**RE: Executive Summary for LD-25-01 – 1526 Fairview Avenue**  
**PARID: 30-00-18860-00-1/ TMID: 30196 017**  
**Preliminary/Final Major Subdivision & Land Development Plans Review (2<sup>nd</sup> Submission)**

**RE: LD-25-01 – 1526 Fairview Avenue**  
**PARID: 30-00-18860-00-1/ TMID: 30196 017**  
**Preliminary/Final Major Subdivision & Land Development Plans Review (2<sup>nd</sup> Submission)**

# LD-25-01 PRELIMINARY/FINAL MAJOR LAND DEVELOPMENT PLANS

RECORD PLAN  
(SHEET 1 OF 1 TO BE RECORDED)

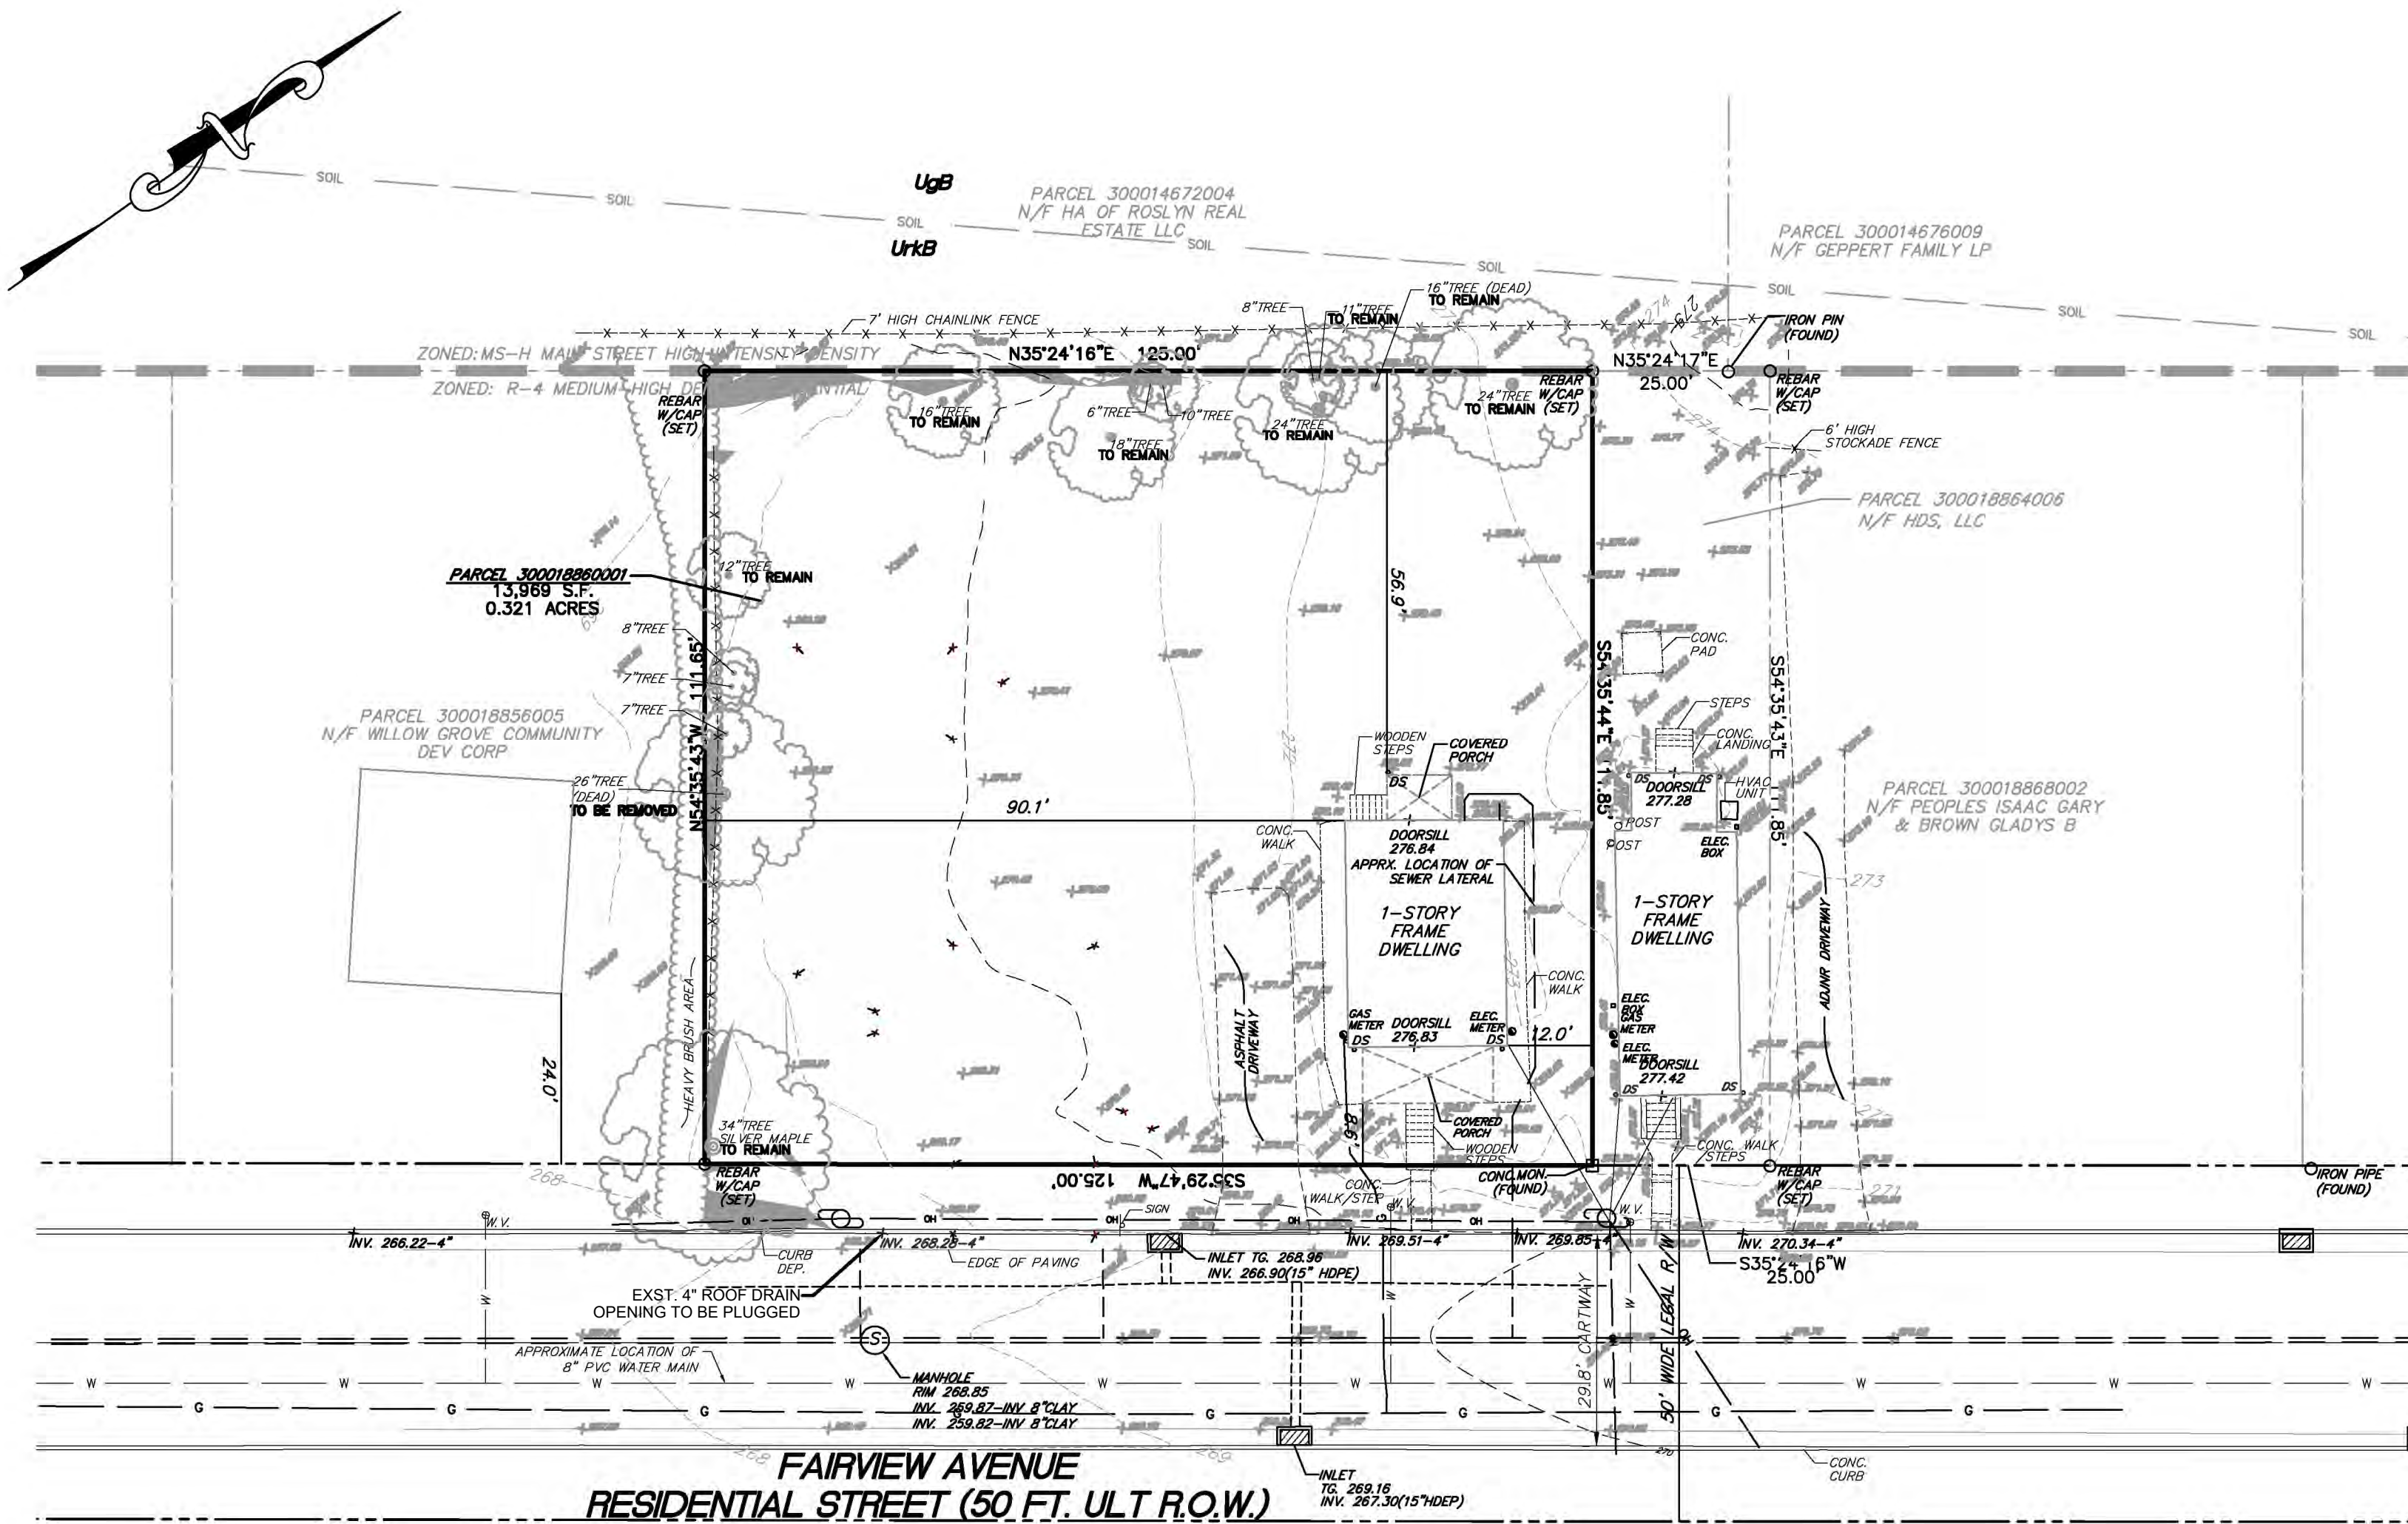
**The condition of approval for the above variances shall be included on the Record Plan (Sheet 1).**

**The Applicant has revised the plans to “Preliminary/Final Major Land Development Plans,” and is indicating they are requesting a waiver to allow for one stage LD approval process. The waivers requested list on the Record Plan does not indicate that a waiver is requested from this Code Section. The Record Plan shall be revised to include this waiver request, and an updated waiver request letter shall be provided for review.**

**Provide additional room for the seal of the Township Engineer to ensure no text overrides with the secretary's signature line above in the "Board of Commissioners Approval" signature block on the Record Plan (Sheet 1).**

4. Plan sheets to be recorded shall be indicated on the Record Plan (Sheet 1). Plans to be recorded shall include Sheets 1, 3, 4, and 8.

**The condition of approval for the above variances shall be included on the Record Plan (Sheet 1).**

**This waiver request shall be revised on the waiver request letter and the Record Plan (Sheet 1) to indicate the correct Code Section of §146-33.G instead of “§146-33(7)” which does not exist in the current SALDO code.**

**This waiver request shall be revised on the walver request letter and the Record Plan (Sheet 1) to indicate the correct Code Section of §146-35.C.(1) instead of “§146-35(3)(A)” which does not exist in the current SALDO code.**

52. The Index of Sheets on the Record Plan (Sheet 1) shall indicate which plans are to be recorded.
53. The narrow longitudinal zoning district abutting the R4 zoning district located to the east of the site on the Location Map is mislabeled as "MS-H" and should be corrected to the "MS-L" zoning district. Similarly, the "MS-H" label for the horizontal area between Arnold Avenue and Fairhill Avenue should also be corrected to the "MS-L" zoning district.

**EXISTING FEATURES, ERSAM PLAN, & DEMOLITION PLAN**

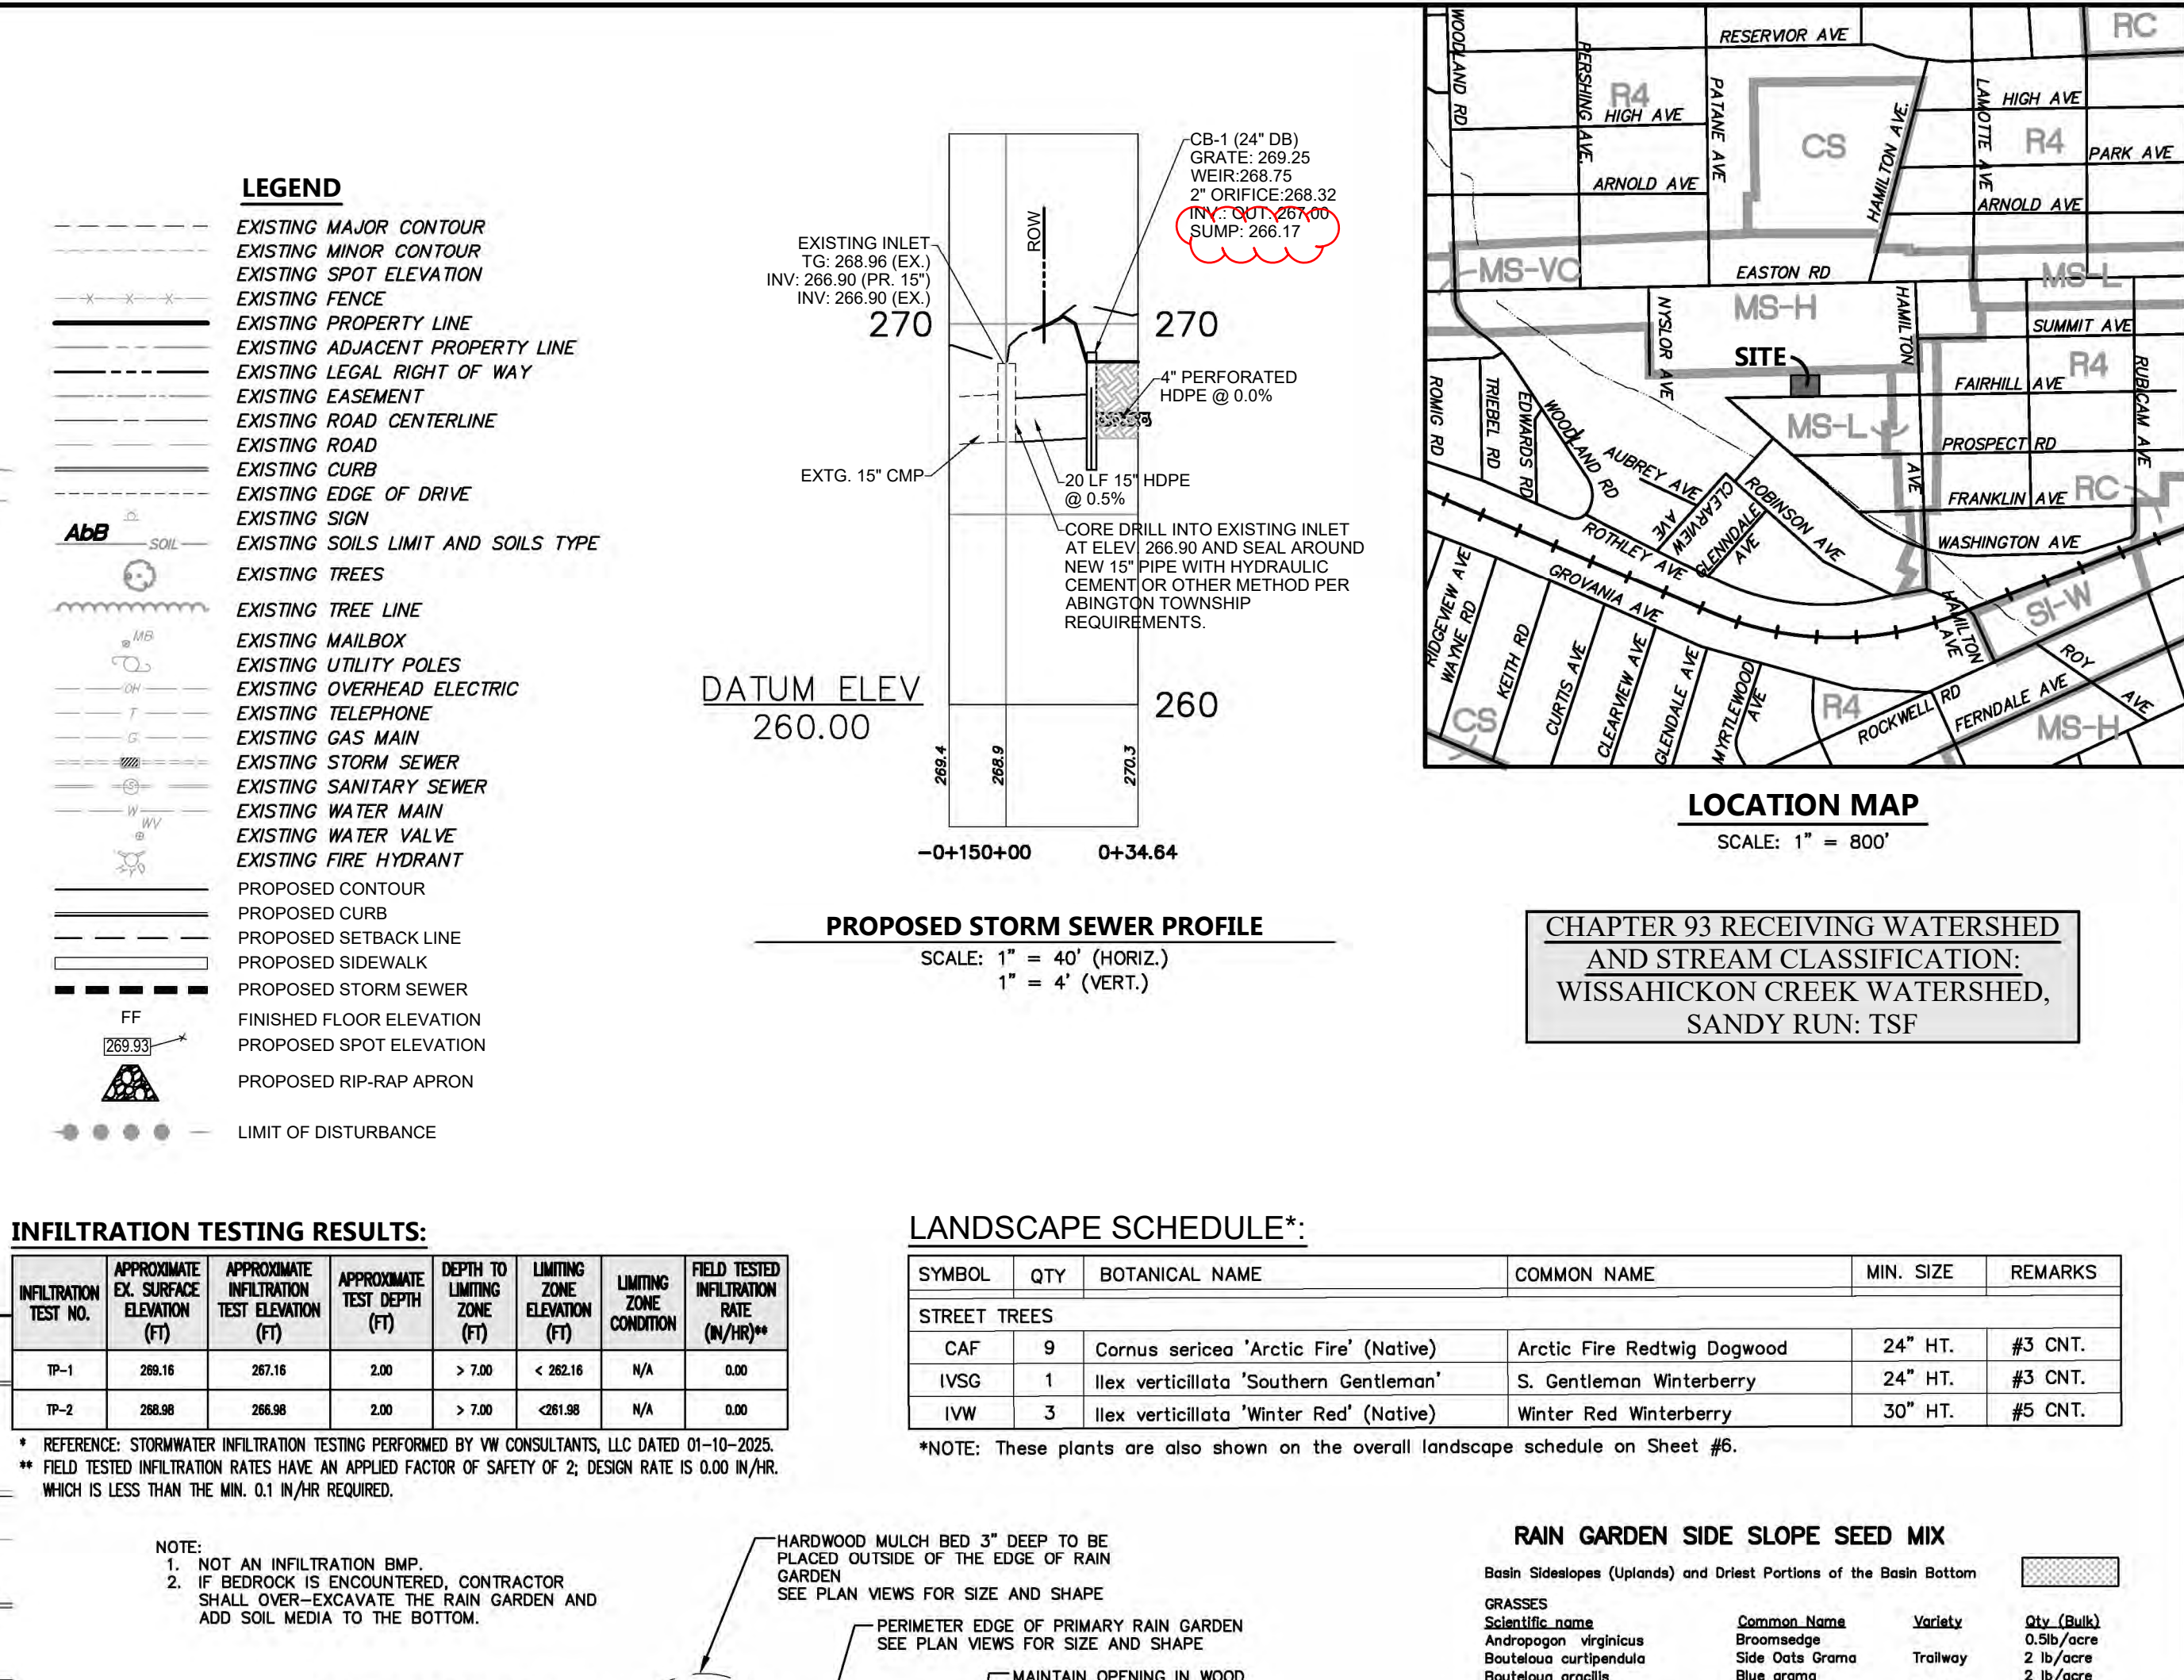
**Each mature tree with a 10-inch caliper or greater shall be clearly shown on the plans and indicated if these trees are to remain or to be removed on the Existing Features and Demolition Plan (Sheet 2).**

The "existing water valve" symbol in the diagram does not match the symbol in the legend (Sheets 2 thru 6). The legends and/or diagrams shall be revised to ensure that this feature, as well as all others, are correctly labeled.

LEVIN A. KESTER \_\_\_\_\_ DATE \_\_\_\_\_  
PENNSYLVANIA PROFESSIONAL  
LANDSCAPE NUMBER LA-000883-E

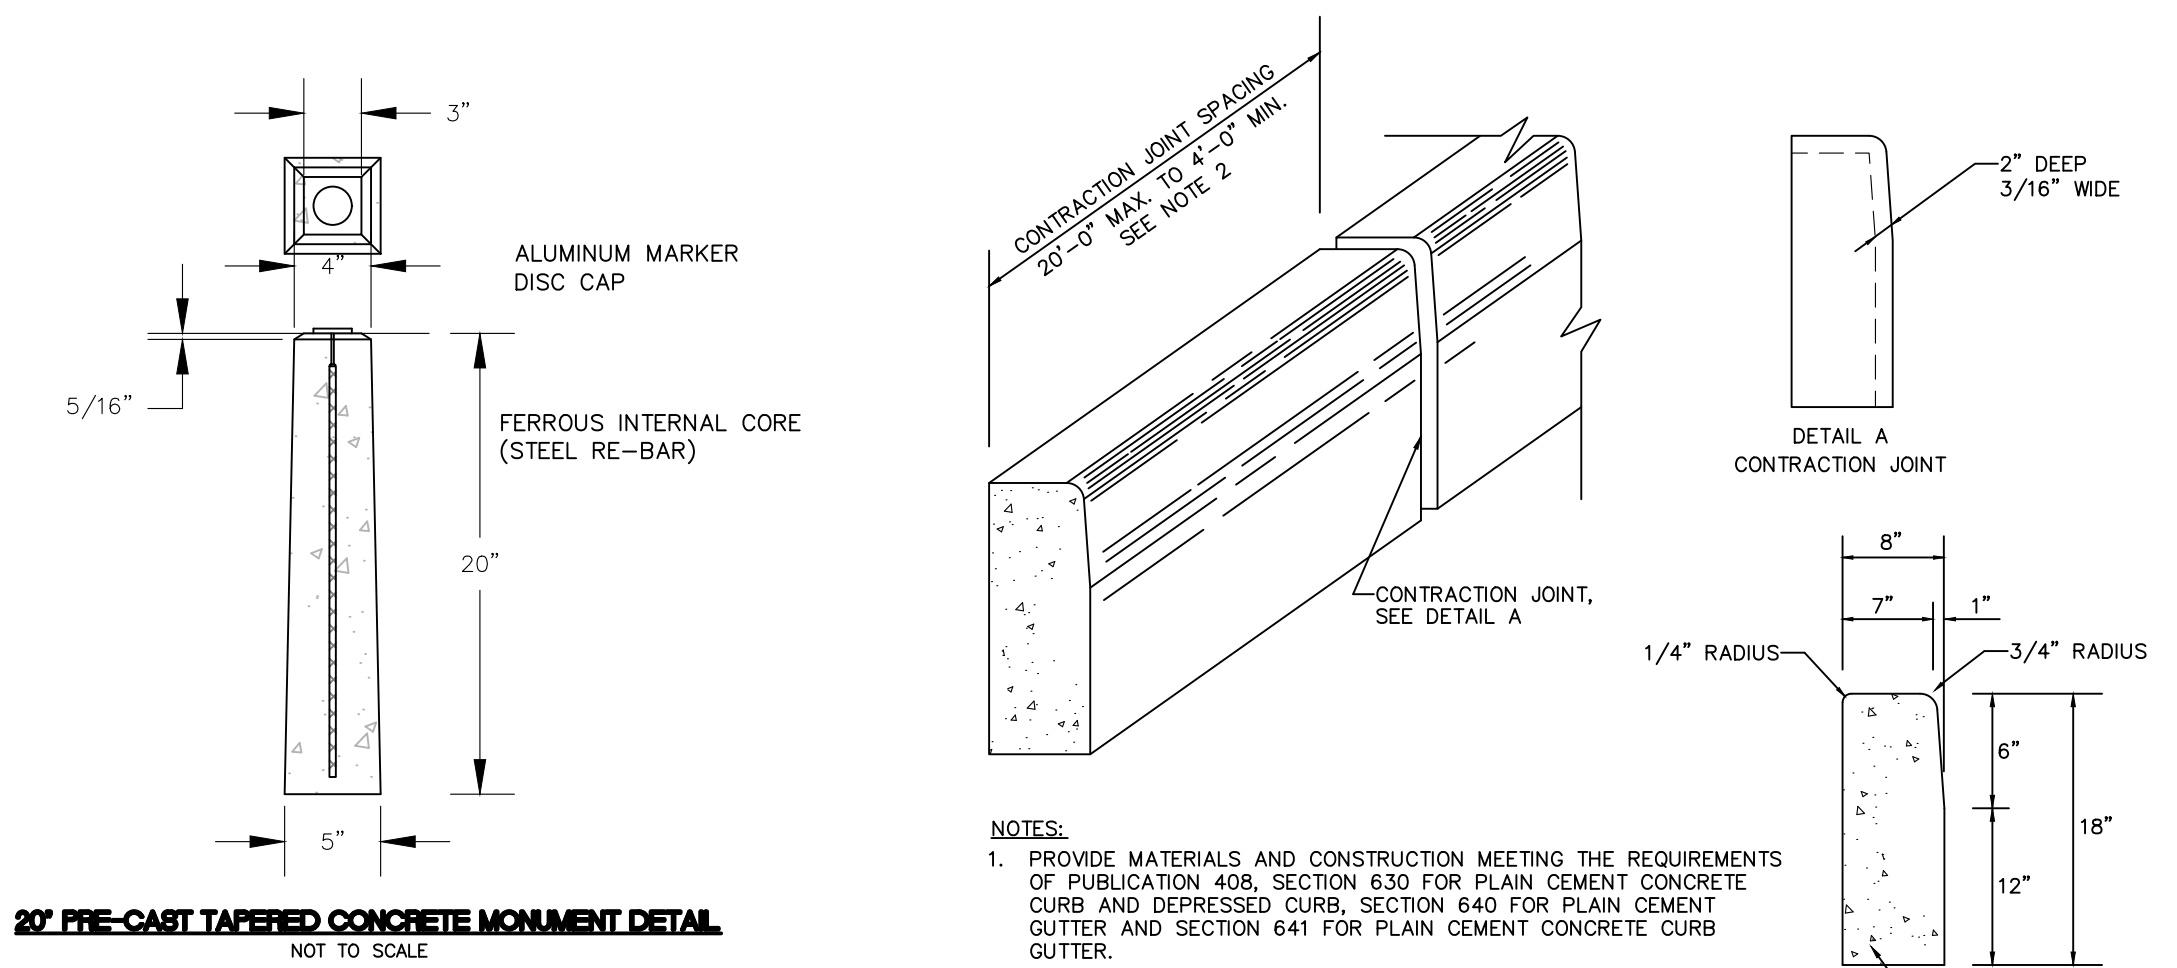
*The Landscape Plan (Sheet 9) shall be prepared by a registered landscape architect. The signature and seal of that registered landscape architect shall be provided on the plans.*

**The landscape plan shall be signed and sealed by a registered landscape architect prior to recording plans approval.**

**The Landscape Plan (Sheet 9) shall be prepared by a registered landscape architect. The signature and seal of that registered landscape architect shall be provided on the plans.**
